ADDENDUM #2 TO THE BID DOCUMENT AND SPECIFICATIONS FOR EMERGENCY POWER GENERATORS FOR CITY FACILITIES

Emergency Power Generators at City Facilities Bid Response Form – Addendum #2

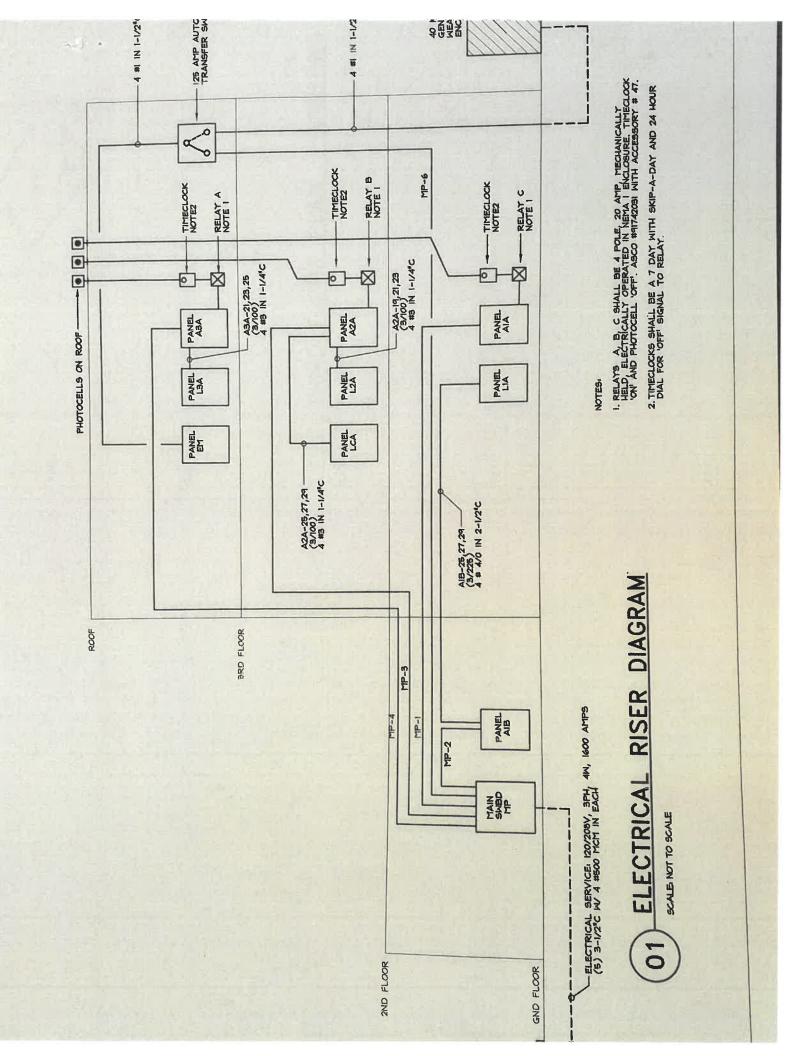
Please see the attached photos of the existing as-built drawings of the electrical riser. Also attached is a photo of the mapping of each switch from the switchgear.

There was no 600 Amp Main. Technically, they're all mains.

The 1600 Amp service switch call-out was appropriate.
